Access Compliance Report Public Rights-of-Way (Curb Ramps)

Intersection ID: 30500 Main Street: ORCHARD_GRASS_CT Cross Street: YOUNG_FAWN_CT Location: NW

ADA ID: C321C16AC33D Ramp Type: PerpDiag Initial Pass/Fail: Fail Overall Compliance: No Severity Score: 31.25

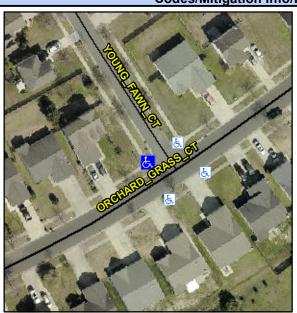
Field Measurements/Component Compliance					
Compliance Description		Data	Comp	liance Description	Data
N/A	Ramp Length (in)	69.0	No	Ramp Slope (%)	8.7
No	Ramp Width (in)	34.0	No	Ramp XSlope (%)	2.8
N/A	Flare Type LT	N/A	N/A	Flare Type RT	N/A
N/A	Flare Slope LT (%)	N/A	N/A	Flare Slope RT (%)	N/A
N/A	Flare Traversable LT?	N/A	N/A	Flare Traversable RT?	N/A
N/A	Landing Length (in)	N/A	N/A	DWS Provided?	N/A
N/A	Landing Width (in)	N/A	N/A	DWS Contrast?	N/A
N/A	Landing Slope (%)	N/A	N/A	DWS Length (in)	N/A
N/A	Landing X Slope (%)	N/A	N/A	DWS Full Width?	N/A
N/A	Landing Curb? (Y/N)	N/A	N/A	DWS Offset (in)	N/A
N/A	Shared Landing?	N/A			
N/A	Gutter Ponding?	N/A	N/A	Gutter Slope (%)	N/A
N/A	Gutter Lip Ht (in)	N/A	N/A	Gutter X Slope (%)	N/A
N/A	Painted X Walk1?	No	N/A	Painted X Walk2?	No
	X Walk 1 Direction	To SE		X Walk 2 Direction	To NE
N/A	X Walk 1 Width (in)	N/A	N/A	X Walk 2 Width (in)	N/A
	X Walk 1 Slope (%)	0.8		X Walk 2 Slope (%)	2.3

Remove & Replace Curb Ramp With Two New Directional Ramps or Equivalent.

R304.5.1, R304.2.2, R304.5.3
